## **Final Buffer Mitigation Plan**

### **Strawberry Hill Mitigation Project**

**DMS Project #: 100094 | Contract #: 7745 | RFP: 16-007576 | DWR #: 2019-0159**

**RE:** Response to Strawberry Hill Mitigation Project Buffer Plan NCDWR Comments during the Mitigation Plan Review  
DMS Project ID No. 100094, Contract #7745, USACE Action ID #SAW-2019-00124  
DWR #20190159

**Figure 1**  
**Nutrient Offset & Buffer Mitigation Service Area**  
**Strawberry Hill**  
**Mitigation Project**  
 Johnston County, North Carolina

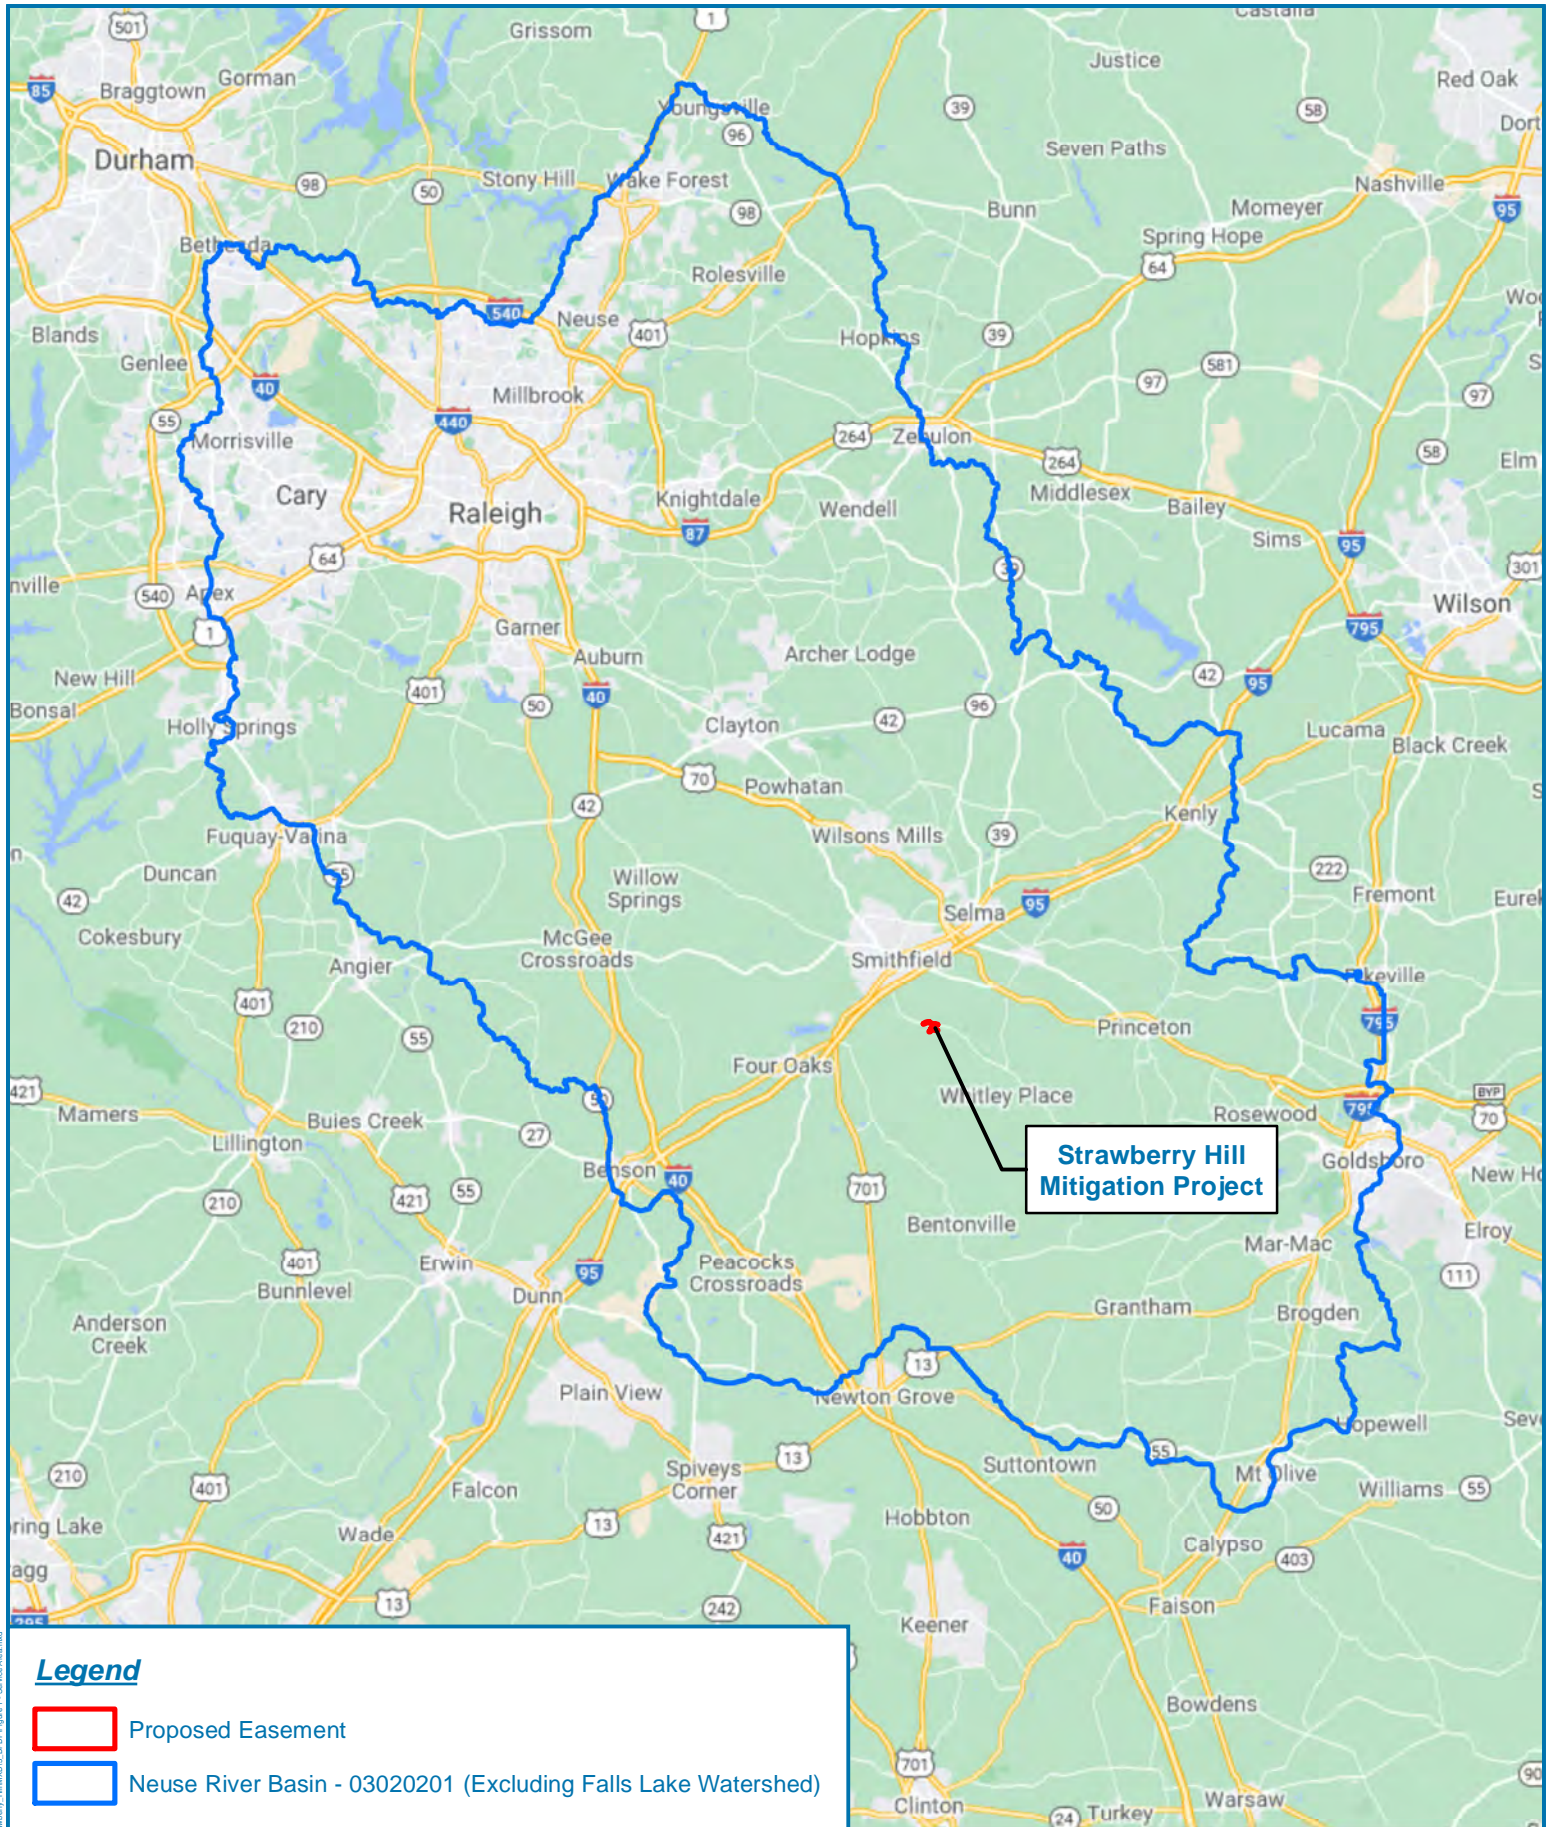
**Figure 1:** This is more of a Vicinity Map, even though titled "Service Area". Modify this figure to include only the Neuse 01 service area excluding the Falls Watershed. You will need to Zoom out to show the entire service area provided by this Project. Since DMs has requested DWR to review this Plan under both 0295 and 0703, please add "Nutrient Offset & Buffer Mitigation Service Area to the Title. These two credit types share the same service area for this Plan.

**Figure 1** has been revised accordingly.

Figure 2 - Existing Conditions

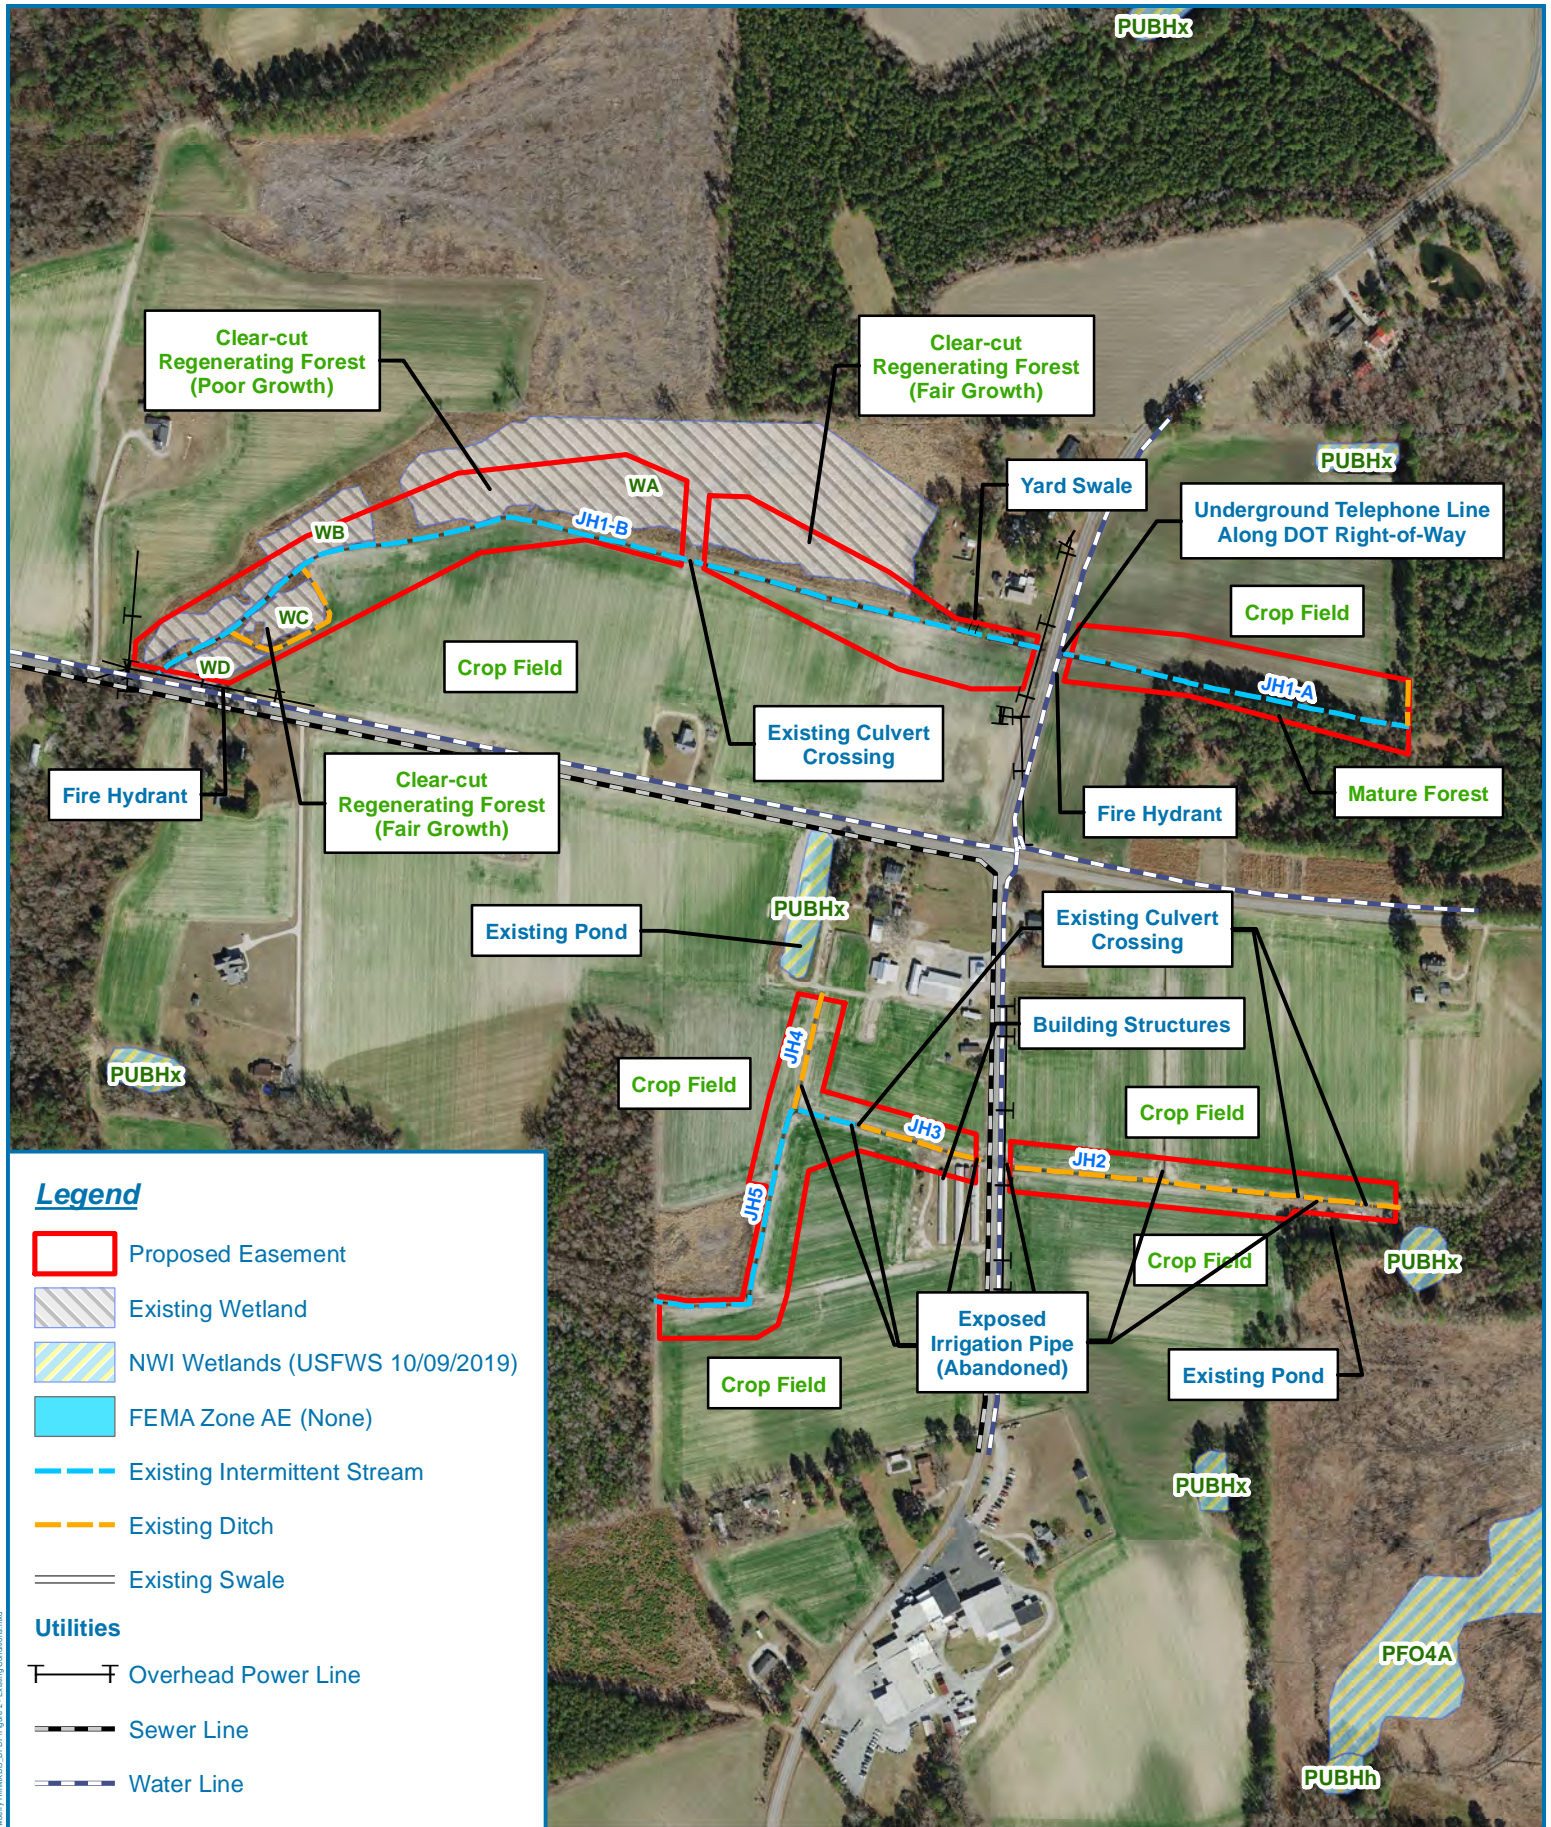
- 3.3: In order to approve alternative planting plans where softwoods are proposed (like Bald Cypress), I need to know that the Provider is planting this species in areas where site wetness is prevalent. The rule gives two scenarios where allowing alternative planting plans: 1) Site Wetness, and 2) availability. Therefore, on the Planting Sheets, indicate where Bald Cypress will be planted. DWR recommends the Provider stick to planting this species along the clear cut riparian areas along JH1B where wetlands have already been identified and represented in Figure 2.

**Figure 4 - Buffer Mitigation Conceptual**

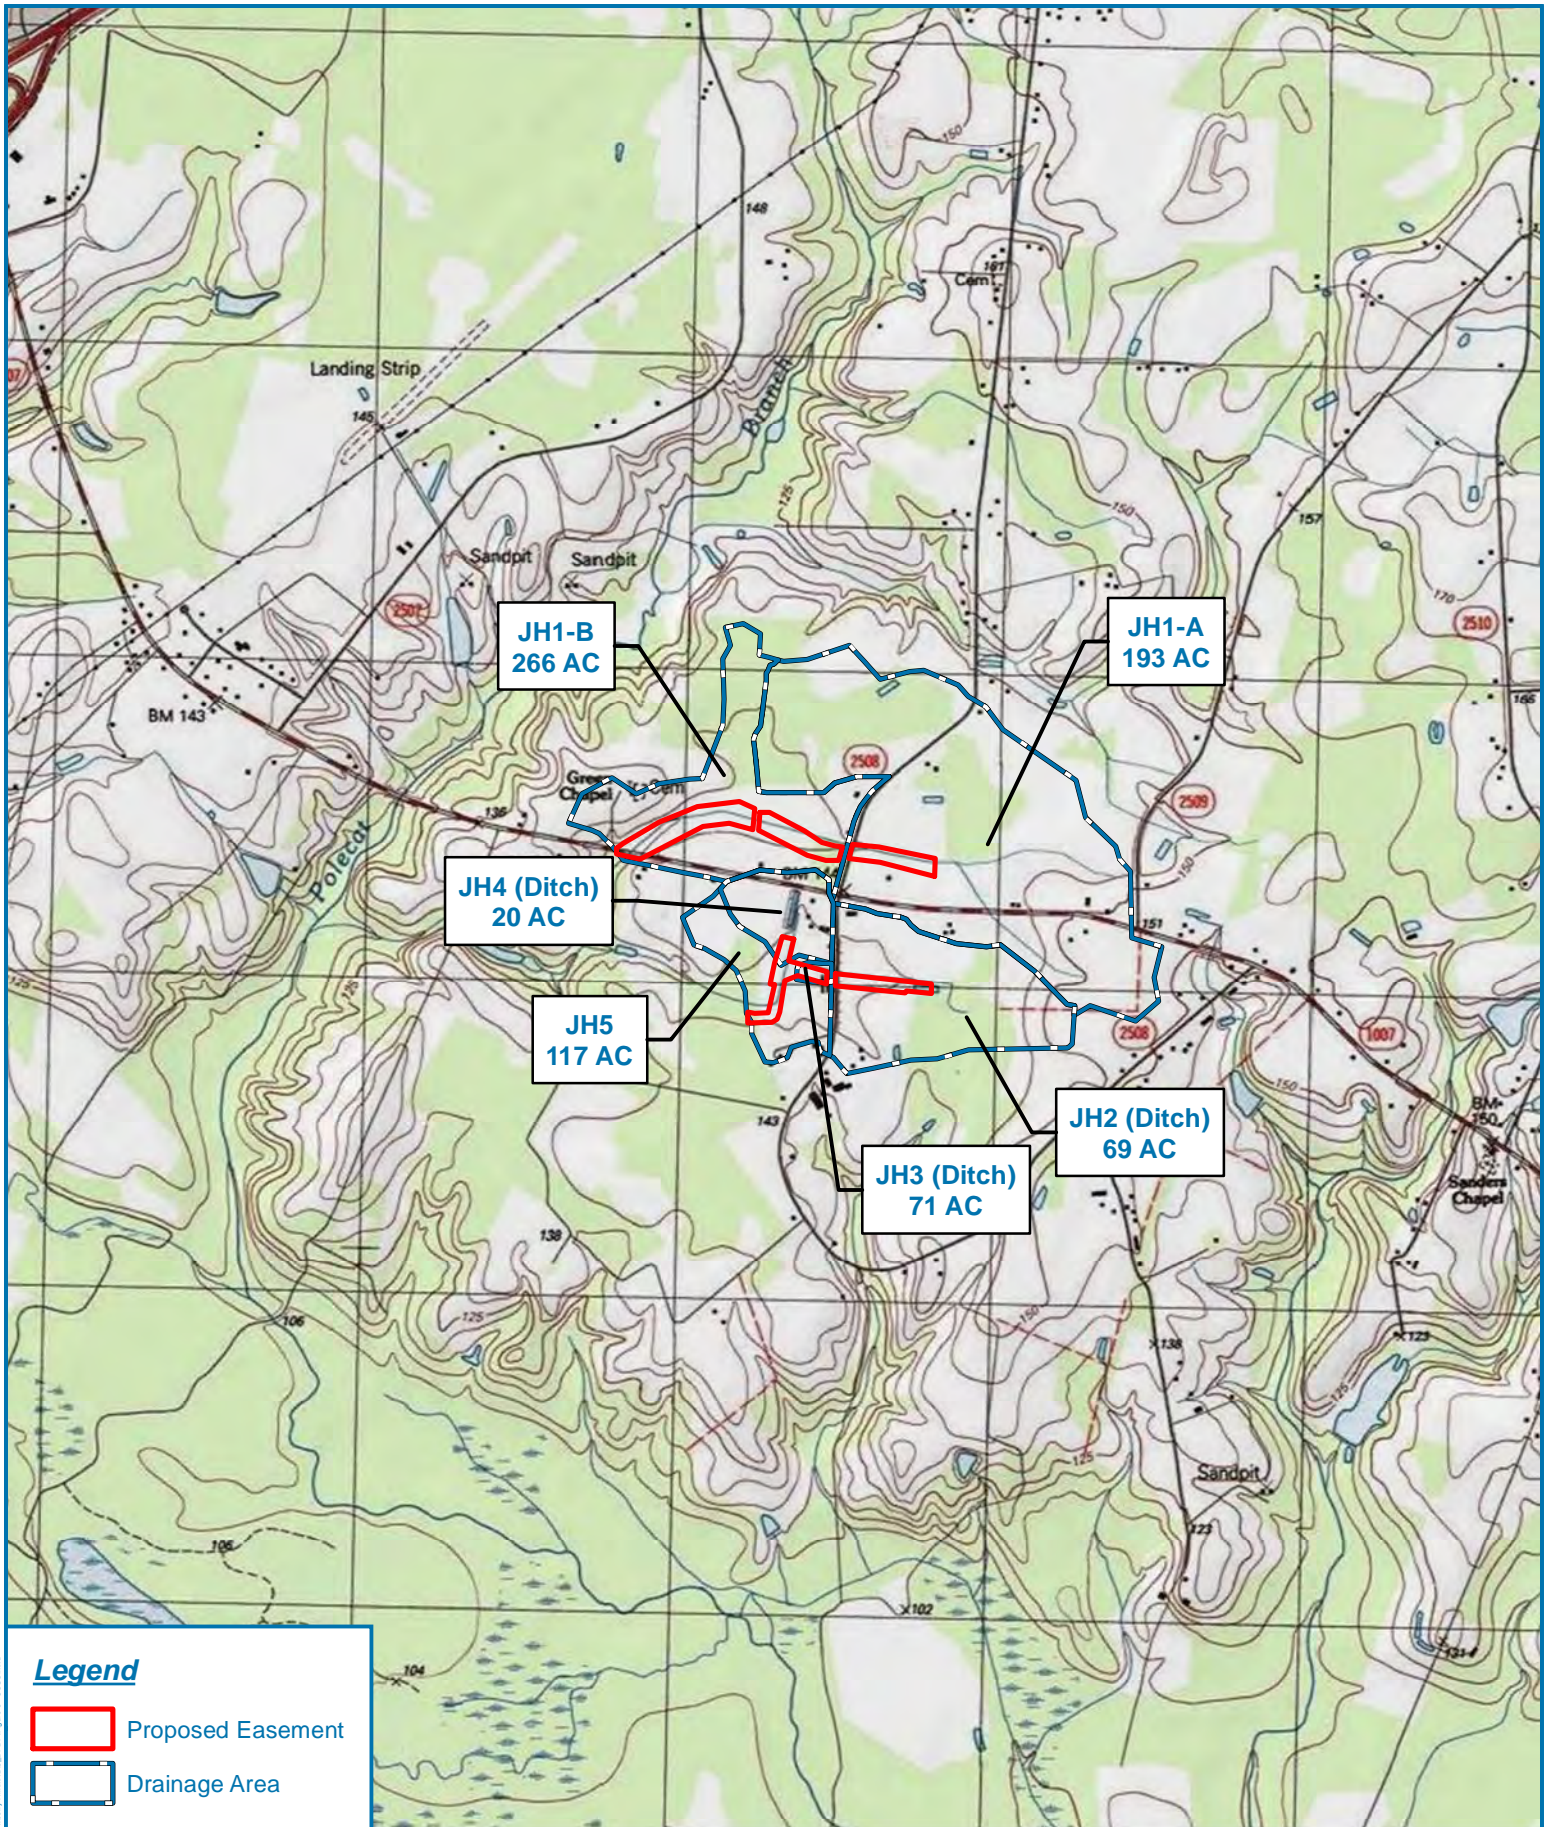
- 3.2.1: In the last paragraph correct the rule reference to be 15A NCAC 02B .0295 (1)(2)(3). Also, identify the untreated flow referenced here along JH1-A on Figure 4.

**Figure 4:**

- There was a statement in the text regarding non-diffused flow at the upper reach of JH1. Can you show where that is?  
**Figure 4** has been revised to include symbology (red crosshatch) to identify each area not receiving credit due to untreated flow (including the area at the top of JH1-A). Also, note that the untreated flow entering at the top of JH1-A is a field-edge ditch along the parcel boundary and is depicted as a “ditch” in **Figure 2 - Existing Conditions**.

- In the legend, call out the areas that not receiving credit due to clear cut in buffer.  
**Figure 4** has been updated accordingly – a red hatch symbol is now included to represent the uncreditable area due to clear-cut of the buffer.

- For this particular site and plan, it is recommended that the widths 0-50, 51-100, 101-200 be outlined and shown around all features, even if the width outline extends beyond the CE boundary. This will help DWR ensure compliance with width requirements for buffer credit & nutrient offset potential. I recommend a thin outline (color coded) to represent each width. You may include this information in a separate Figure if that is preferred.  
A new figure has been created accordingly and is titled “Riparian Zones.” Please note this **Figure 8**.

- Add the word “Riparian” to each mitigation approach category in the Legend, i.e., Riparian Restoration, 0-100.  
Legend has been revised accordingly.
- Don’t see 101-200’ Preservation represented on the Figure. Please point out where this width is represented for Preservation.  
The 101-200’ Preservation area is very small and almost unnoticeable at the scale of this figure. Therefore, a callout has been added to identify this area.

**Figure 4** has been revised to include symbology (red crosshatch) to identify each area not receiving credit due to untreated flow (including the area at the top of JH1-A). Also, note that the untreated flow entering at the top of JH1-A is a field-edge ditch along the parcel boundary and is depicted as a “ditch” in **Figure 2 - Existing Conditions**.
